File ID: 2025-0628 **Substitute 2/10/2026**

Application of LMPSF Acquisitions, LLC c/o Troutman Pepper Locke, LLP to rezone property from C-2 (General Commercial) zoning district to HR-1 (High Density Residential – 1) zoning district to allow for single-family, attached and multi-family developments, at 3265 Northeast Expressway.

Z-25-1247529 (2025-0628)
Recommended Conditions
3265 NE Expressway, Chamblee, GA 30341
February 2026

Site Plan Review (*Illustrative Site Plan - Everstead at Embry Hills, dated 10/17/25*):

DEKALB COUNTY, GEORGIA
ILLUSTRATIVE SITE PLAN | DATE 10/17/2025

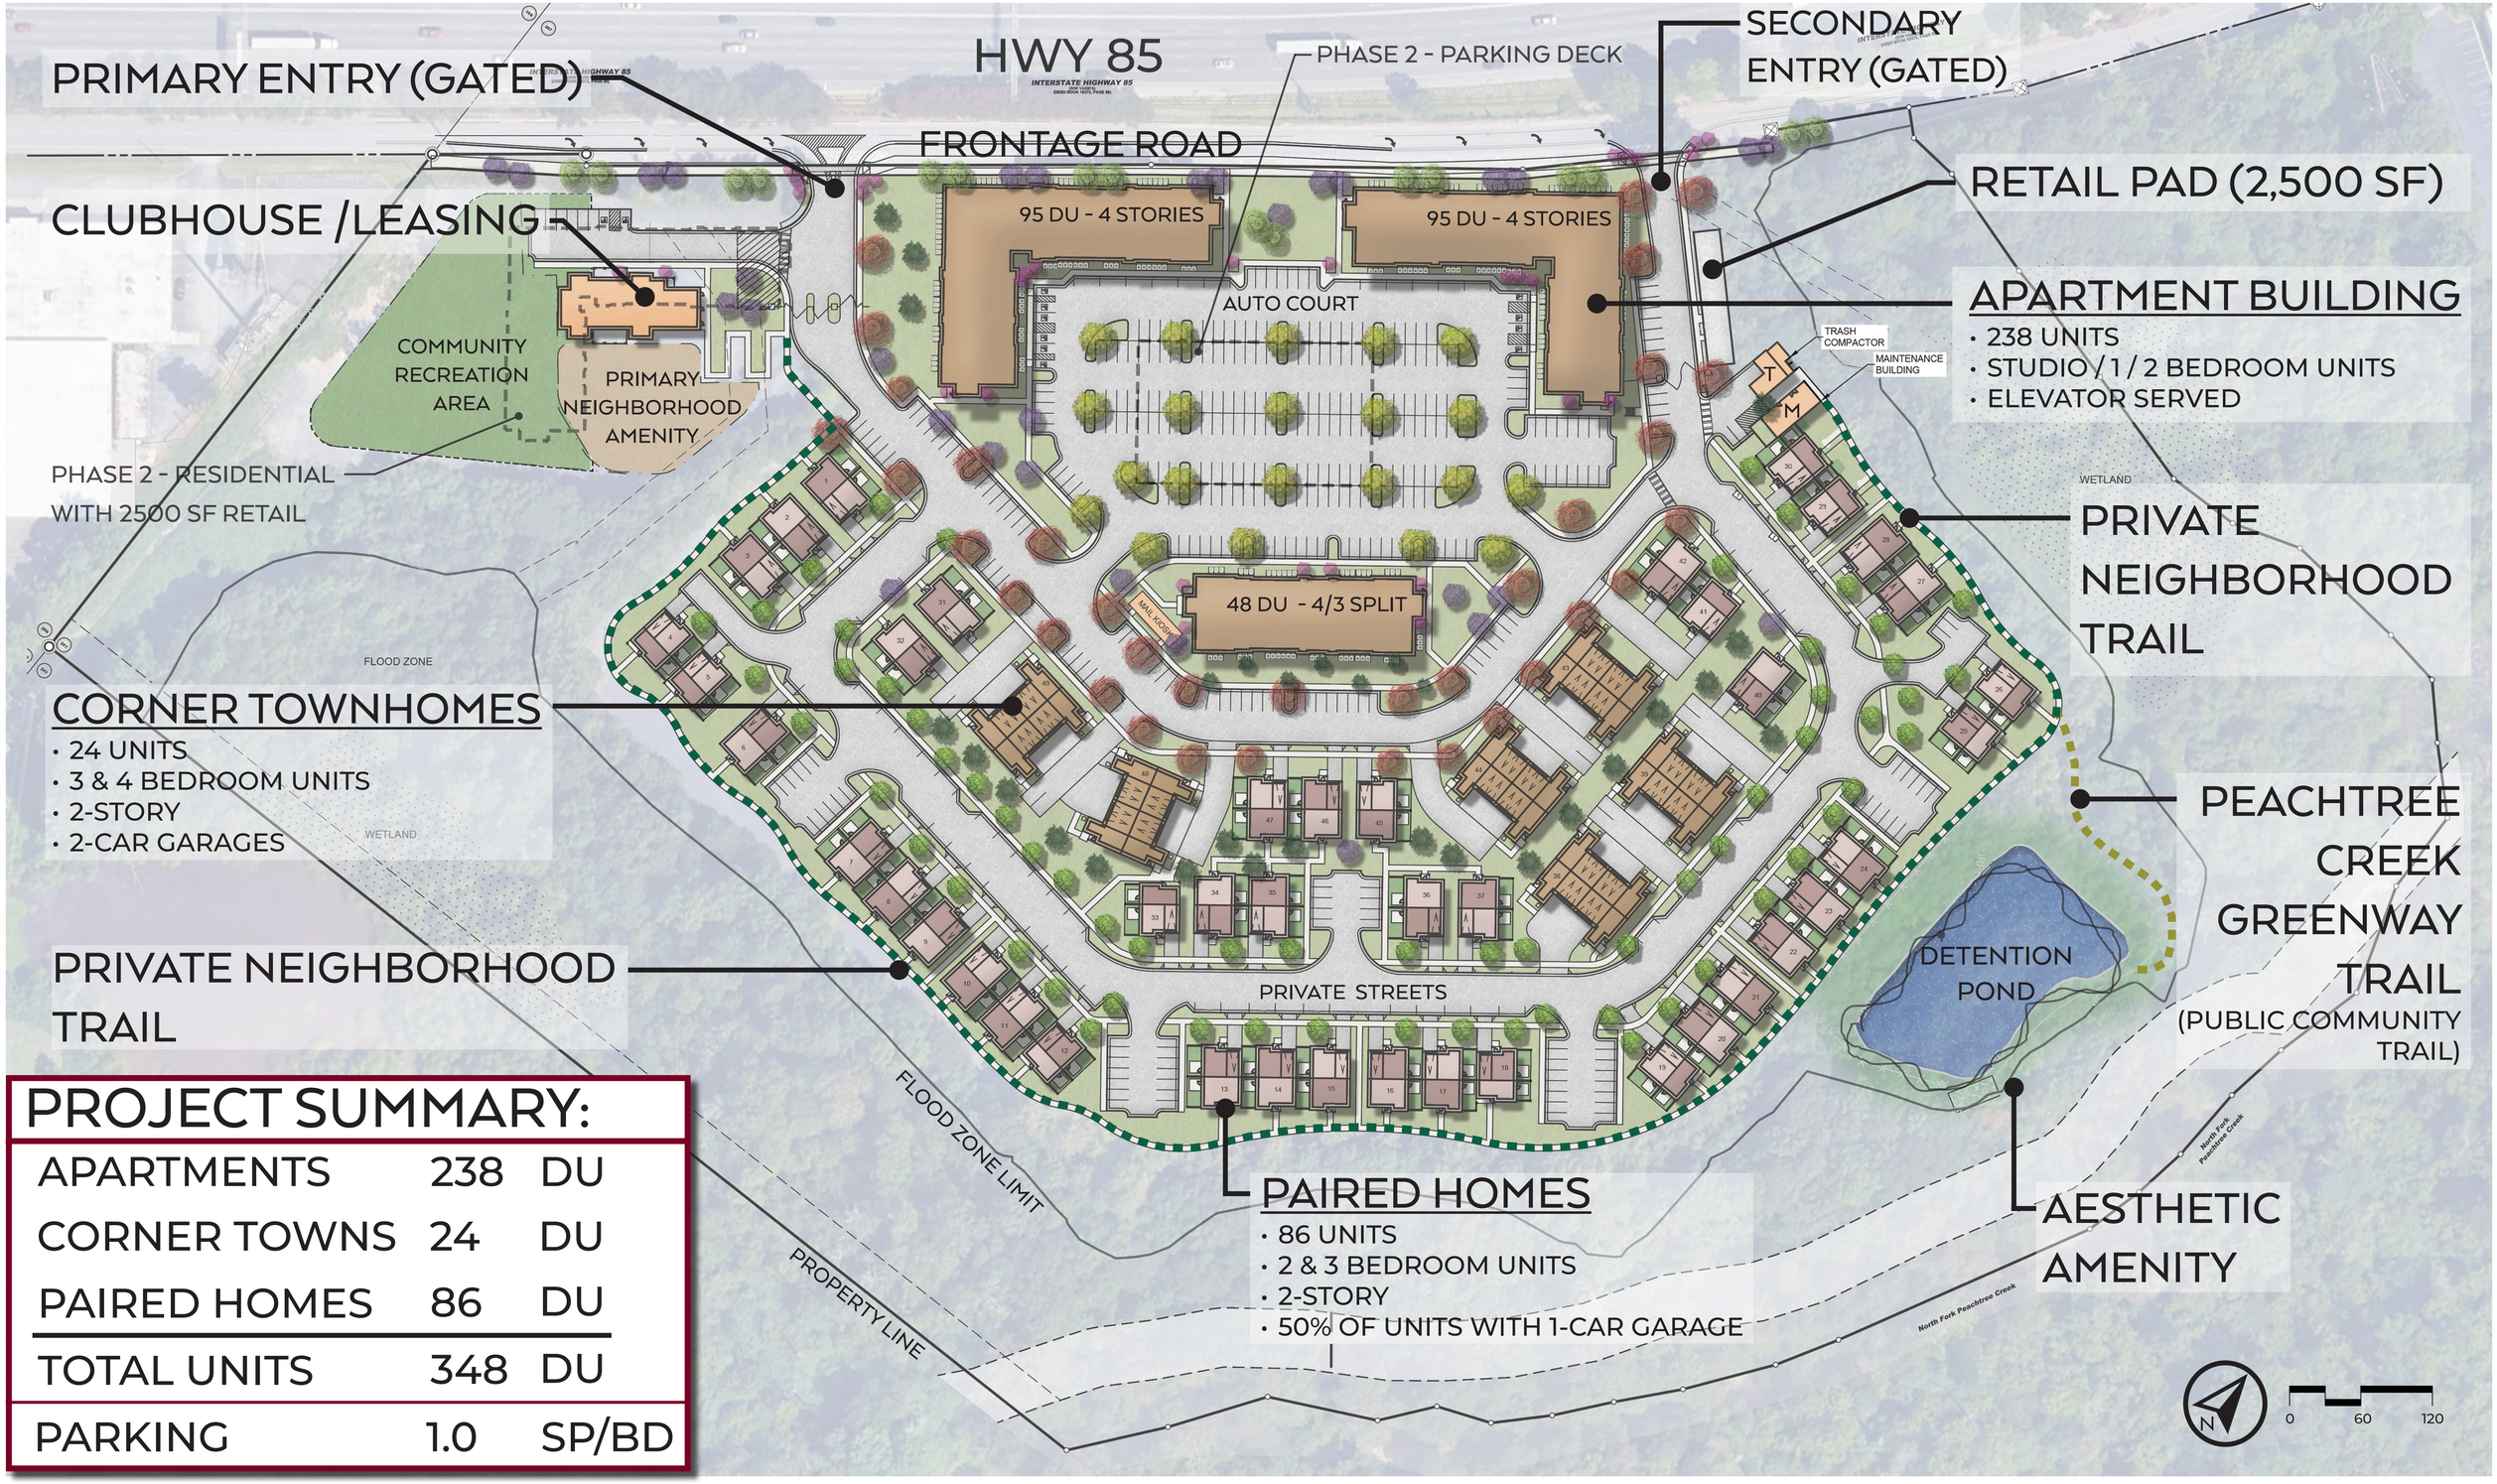
The site plan appears to comply with most of Section *27-2.11.2 – Dimensional Requirements* for HR-1. However, because of the following deficiencies, variances may need to be sought:

- **Interior strips:** Interior to non-residential, mixed-use and multi-family developments, a three-foot (3) wide planted landscape strips shall be required along all interior drives and pedestrian paths per *Section 5.4.4 - Site and Parking Area Landscaping B.* As well as *D. Parking Area Landscaping* tree *and island quantity (4 and 5).*
